WEST CONCRETE WATER STORAGE TANK

ALTERNATIVE LANDSCAPING PLAN & NOTES

100% DESIGN DRAWINGS

C14

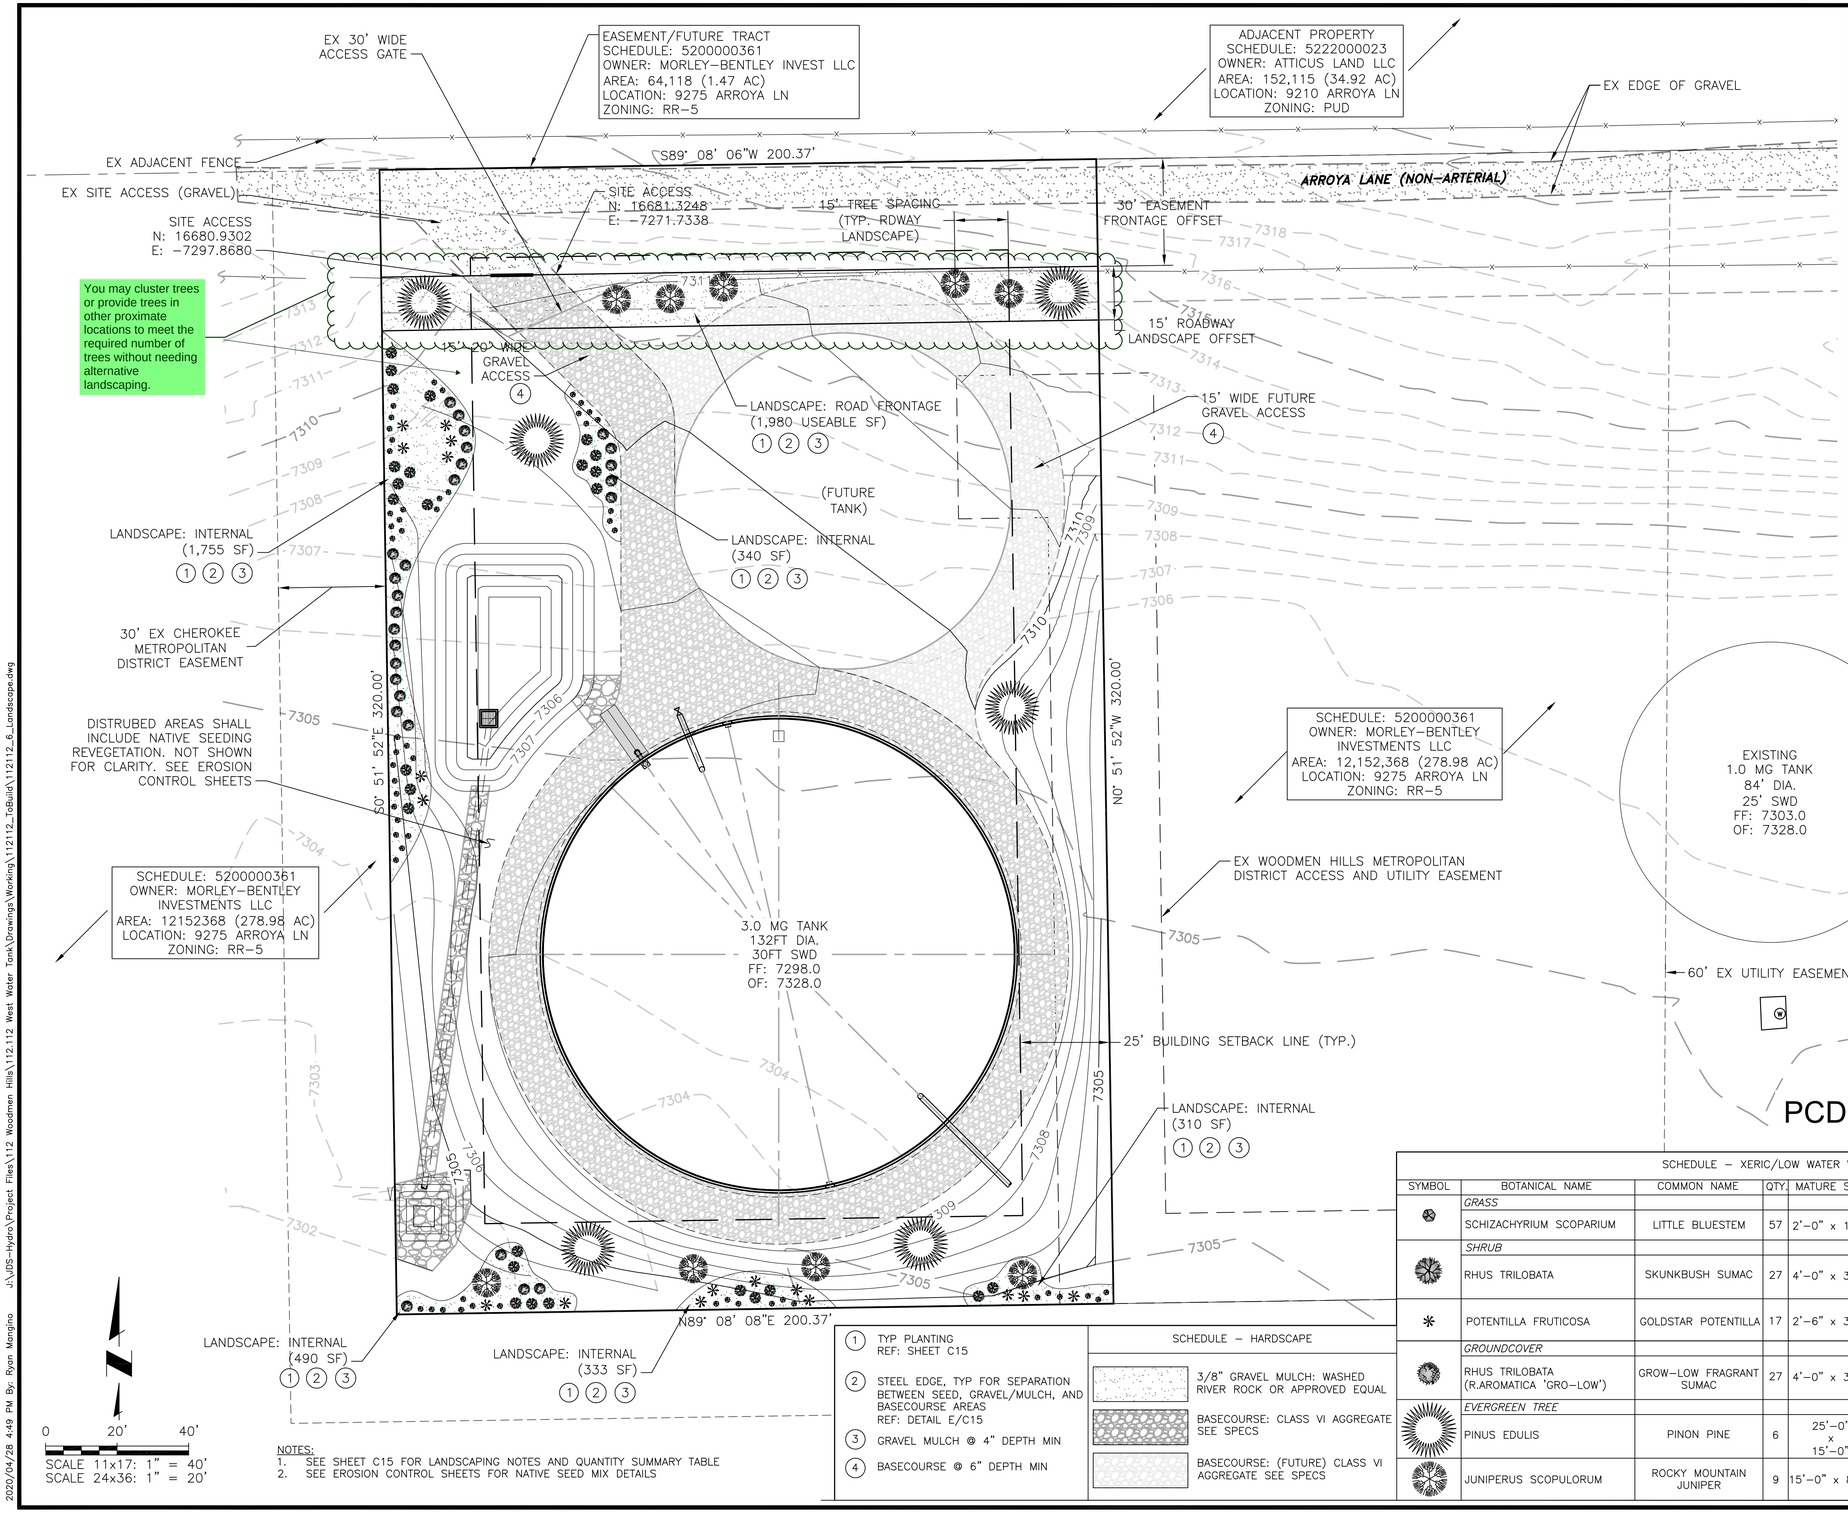
You may cluster trees or provide trees in other proximate locations to meet the required number of trees without needing alternative landscaping.
